REPORT OF ALTERATIONS TO DESIGNATED RESOURCE

Site Number/Address: 421 E. Laurel St.

Laurel School National Register Historic District

This report is to document proposed alterations to the Jackson Norris House at 421 E. Laurel Street, pursuant to Fort Collins Municipal Code Chapter 14, [Article IV](#). A copy of this report may be forwarded to the Colorado Office of Archaeology and Historic Preservation.

2 (N) SOUTH ELEVATION
1/4" = 1'-0"

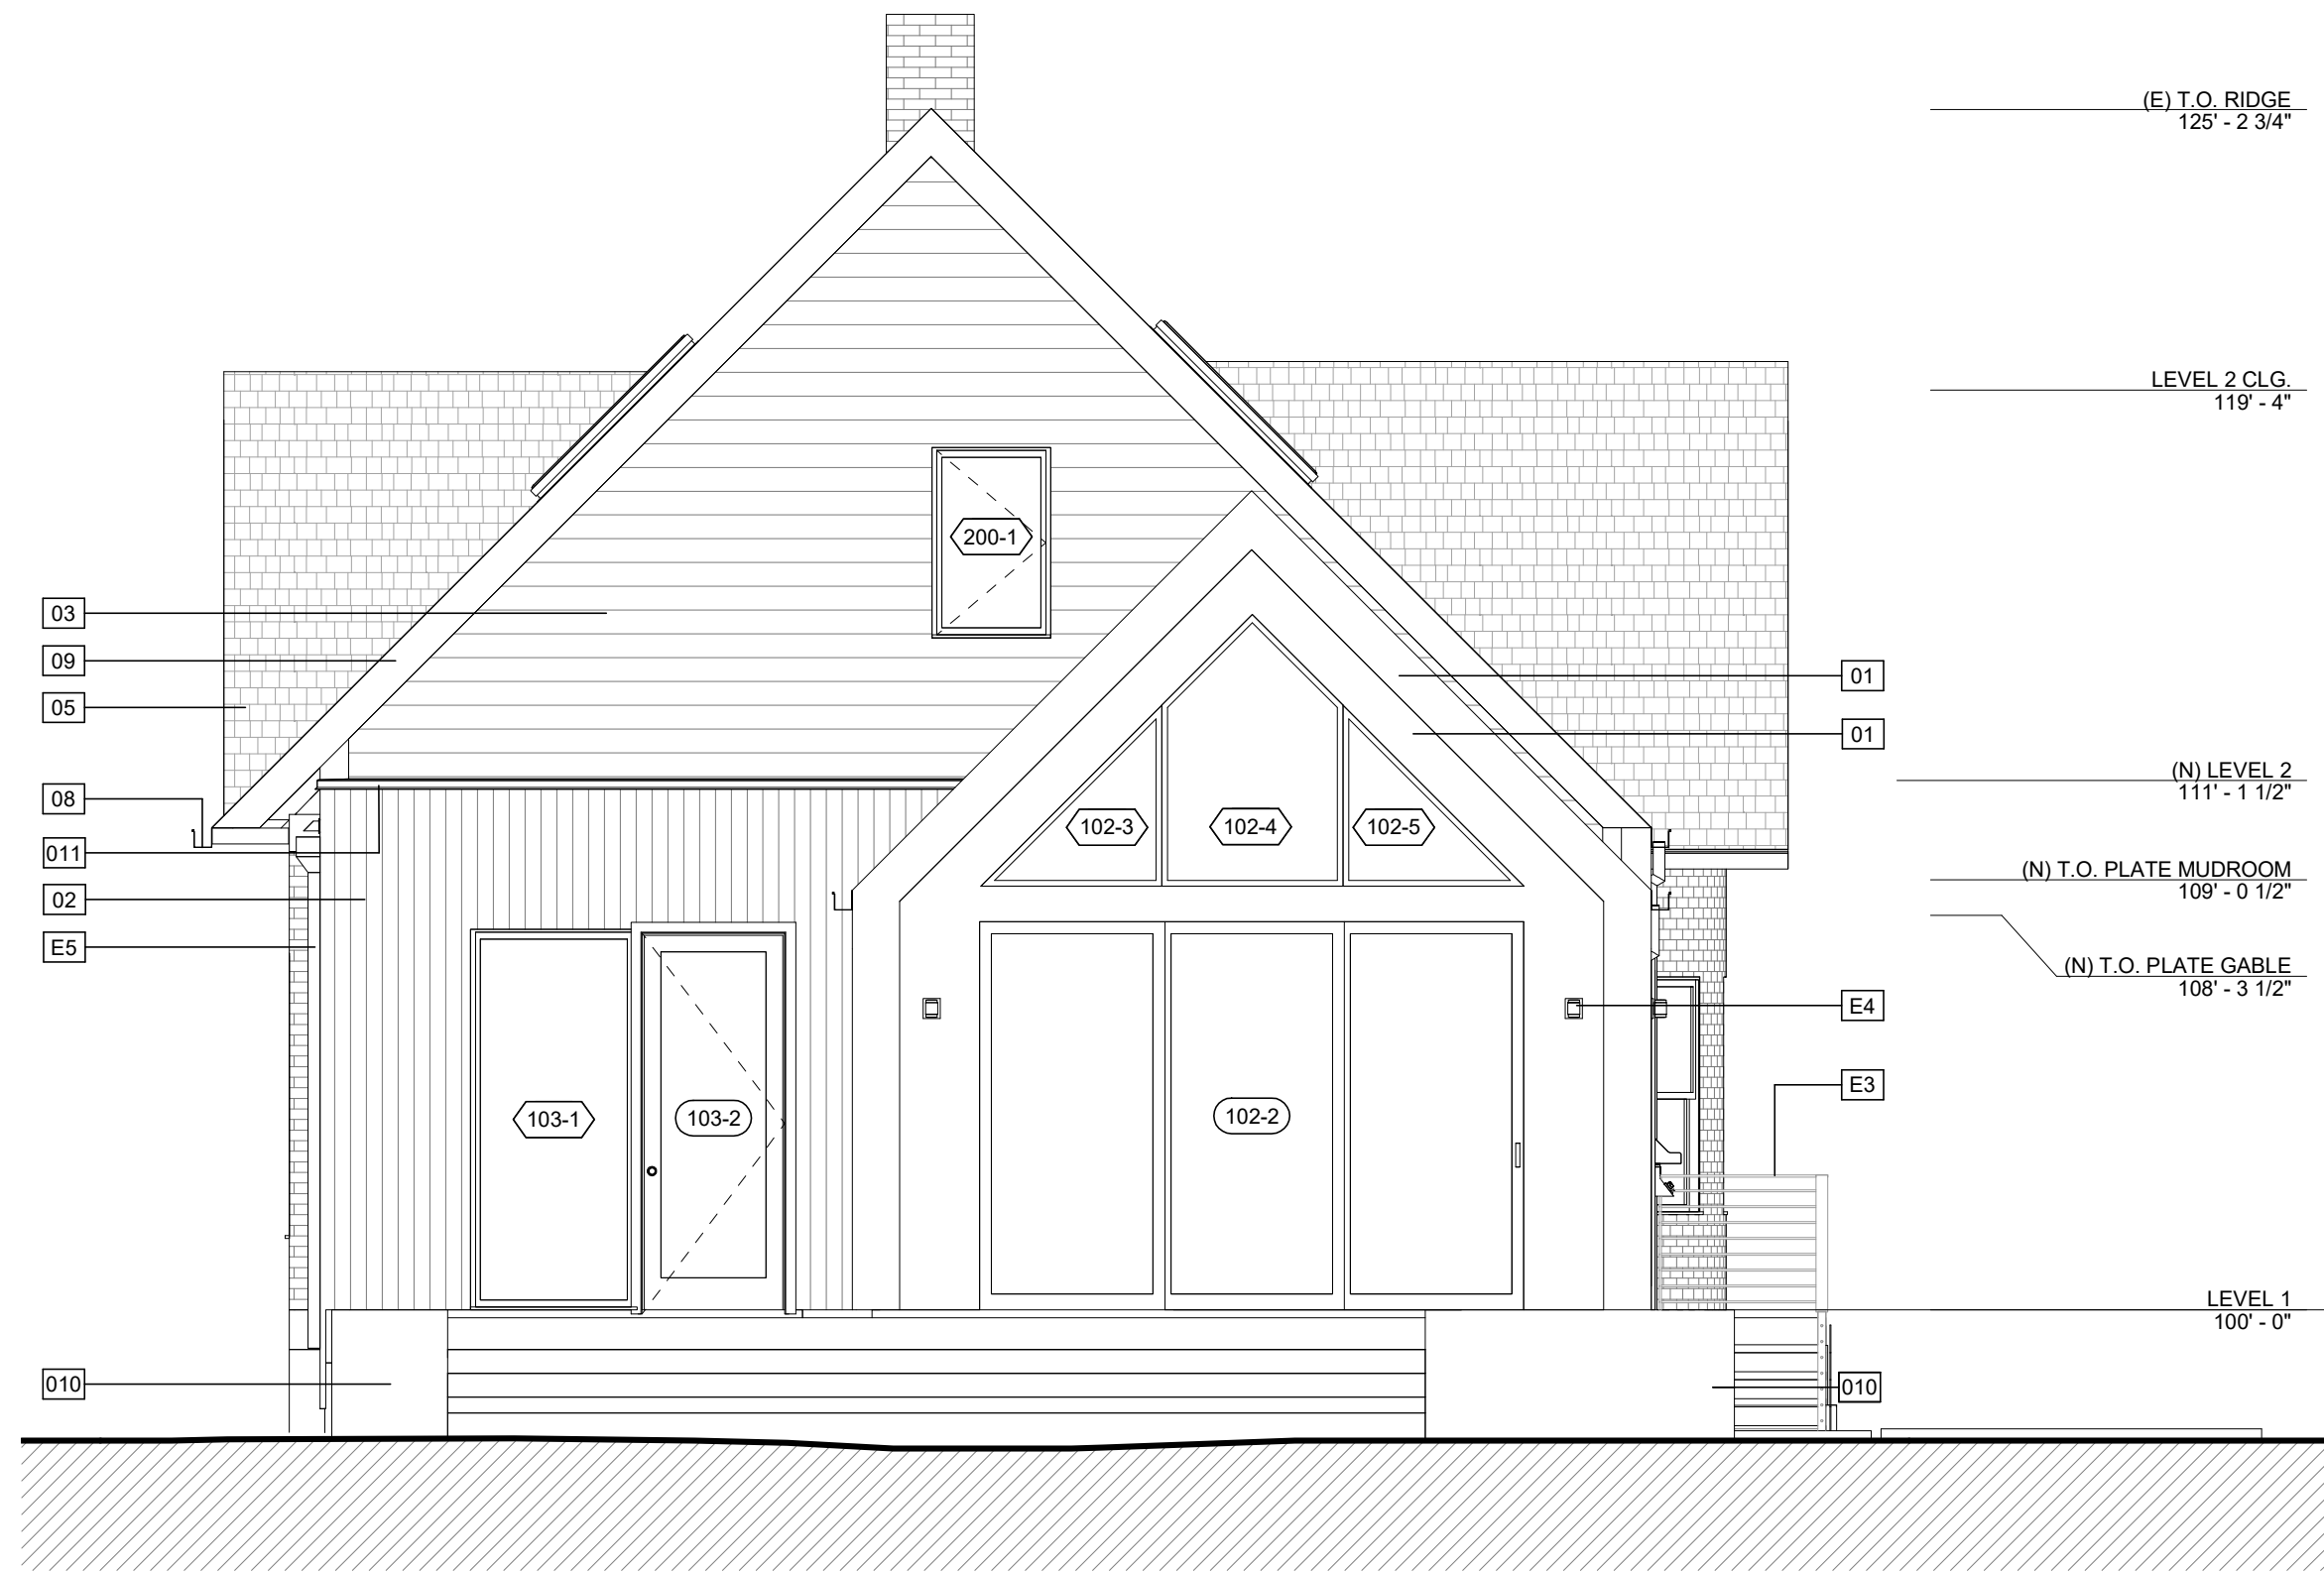
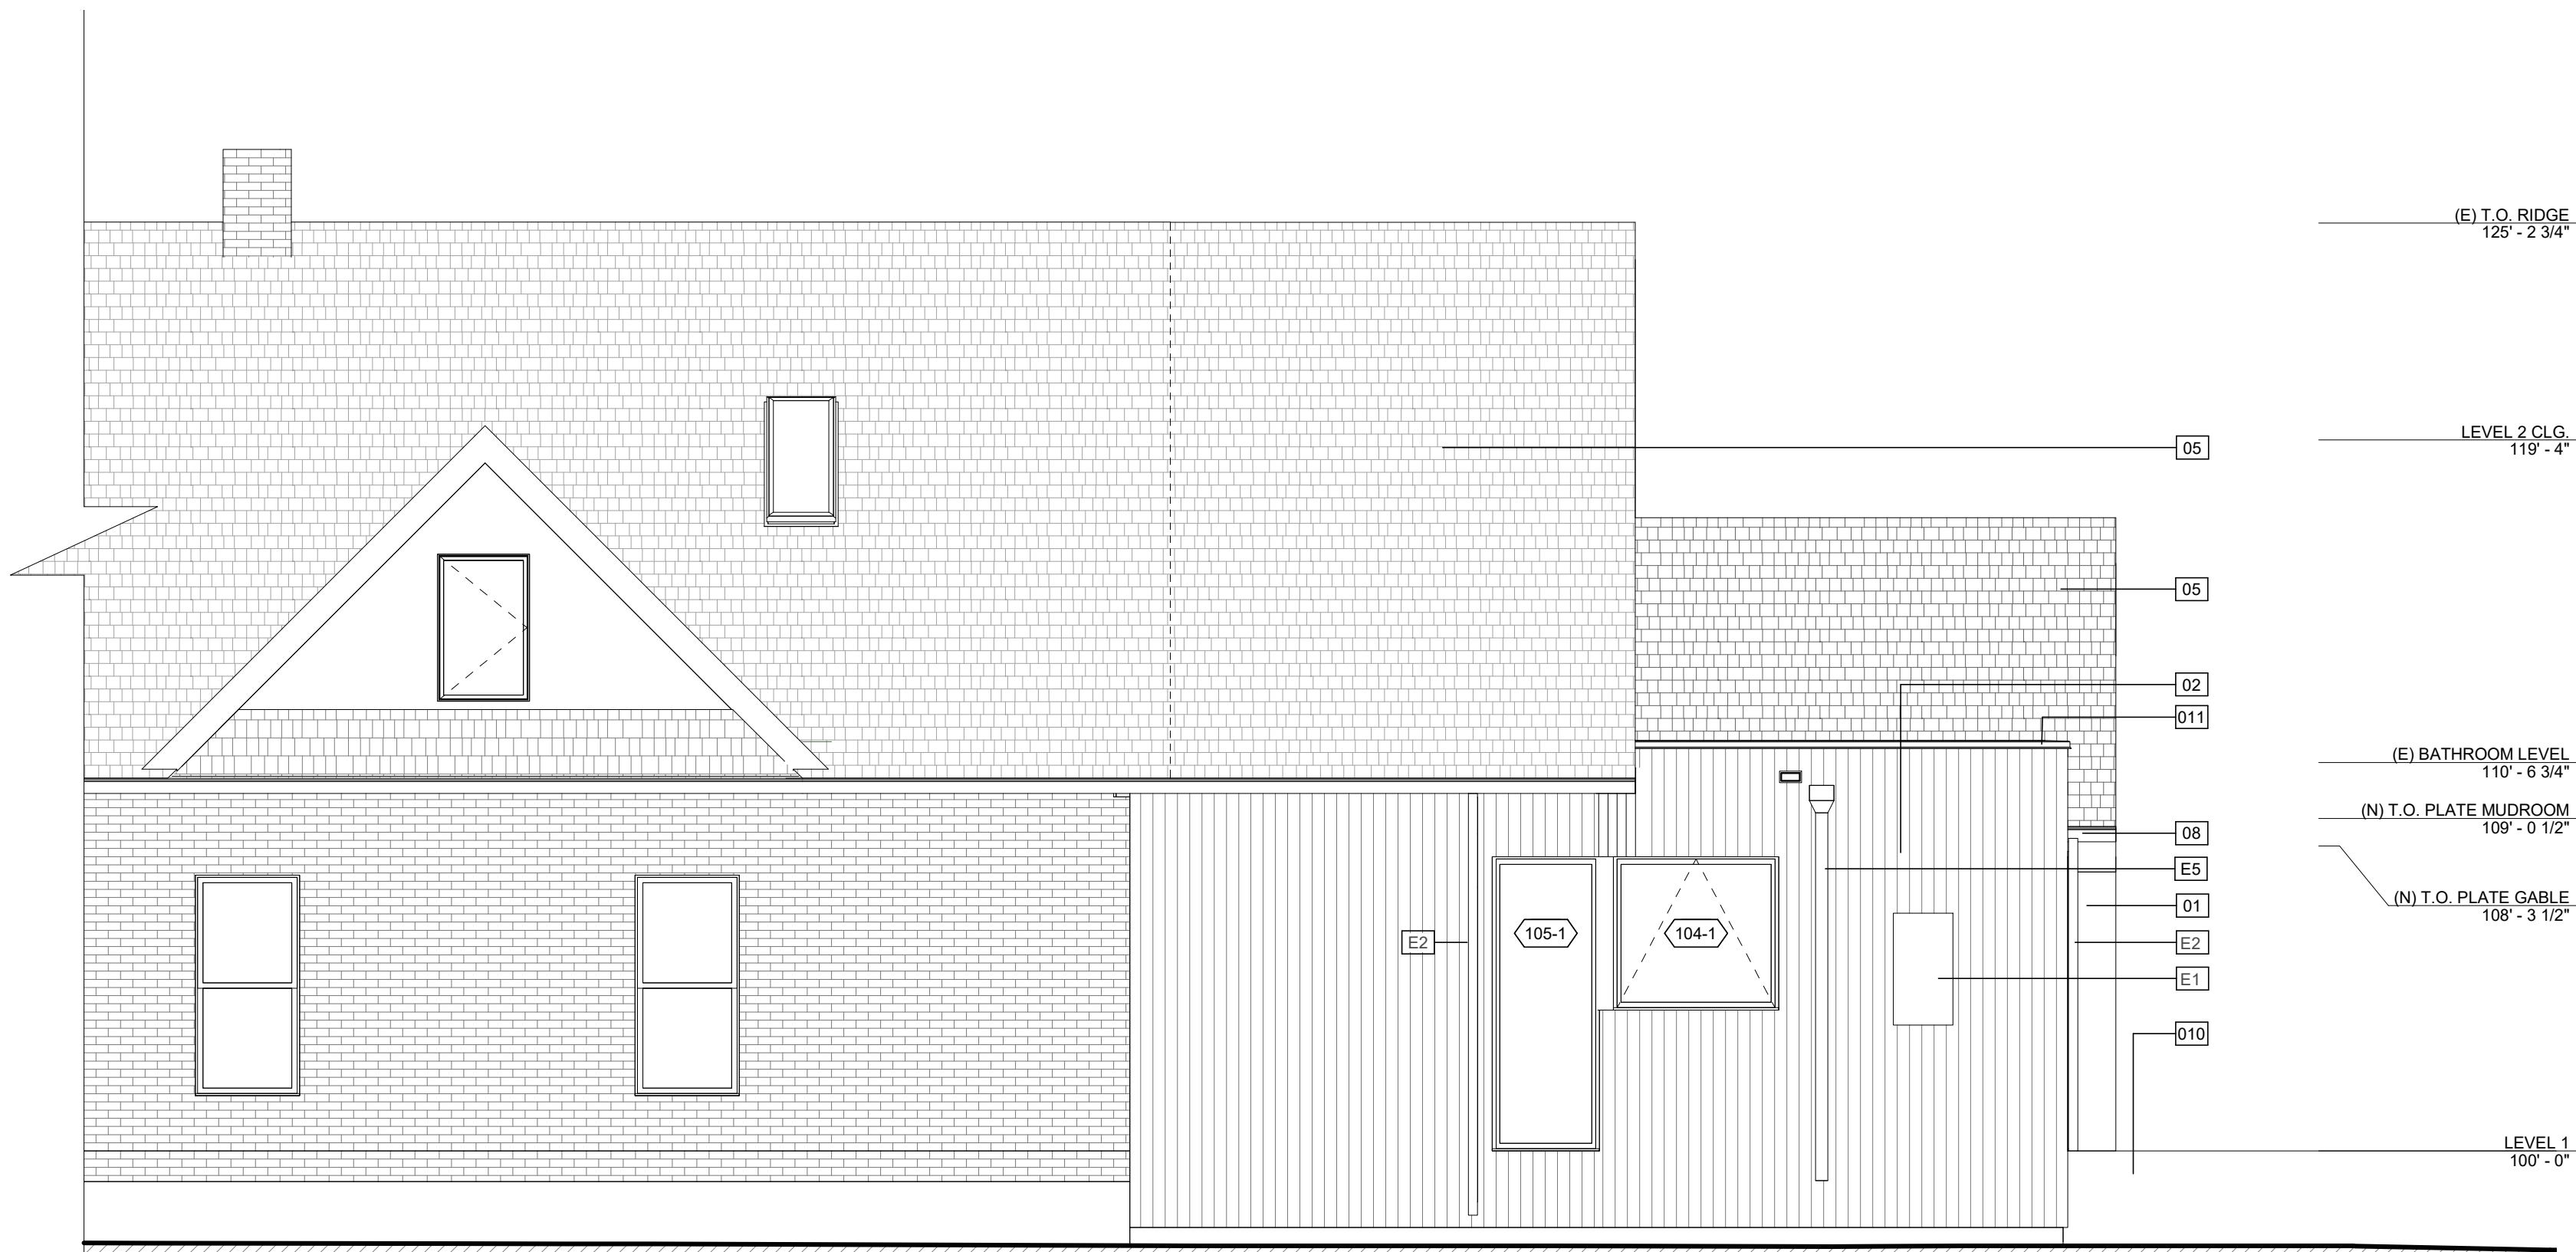
<i>missing features will be substantiated by documentary and physical evidence.</i>	
SOI #7	<i>Chemical or physical treatments, if appropriate, will be undertaken using the gentlest means possible. Treatments that cause damage to historic materials will not be used.</i>	N/A
SOI #8	<p><i>Archeological resources will be protected and preserved in place. If such resources must be disturbed, mitigation measures will be undertaken.</i></p> <p>Excavation appears limited to a few feet to establish a crawlspace under the addition. This soil is already disturbed due to the construction and removal of two sets of additions, soon to be replaced by a third.</p>	Y
SOI #9	<p><i>New additions, exterior alterations, or related new construction shall not destroy historic materials that characterize the property. The new work shall be differentiated from the old and shall be compatible with the massing, size, scale, and architectural features to protect the historic integrity of the property and its environment.</i></p> <p>The project has mixed performance under this Standard. The new addition is compatible with the massing, size, scale, and architectural features of the property. Furthermore, it is differentiated from the historic through the use of different cladding materials and a modern glazing pattern. The addition generally strikes a good balance under this Standard between compatibility with the historic building, and distinguishability as new construction.</p> <p>The main deviation from this Standard is the demolition of elements of character-defining features, namely portions of the rear brick wall on the main section of the house, and removal of the window near the southeast which is being partially infilled and replaced with a smaller window to accommodate kitchen modifications. While much of the project meets this standard, this degree of removal of historic materials is not recommended and does not meet this Standard.</p>	N

SOI #10	<p><i>New additions and adjacent or related new construction will be undertaken in such a manner that, if removed in the future, the essential form and integrity of the historic property and its environment would be unimpaired.</i></p> <p>Related to the findings above, the removal of half of the rear/south brick wall does not meet this Standard. Technically, the window near the southeast corner can be salvaged and retained on site for use elsewhere or if this window is ever returned to its historic condition. However, the removal of half of a brick wall to accommodate the addition attachment does not meet this Standard. Typically, this Standard would call for</p>	N

shifting the floorplan of an addition to adapt to existing openings in the historic building to minimize demolition. While some demolition to widen passageways for modern Code requirements is understandable, wholesale demolition of an exterior wall section is not recommended and does not meet this Standard.	
--	---	--
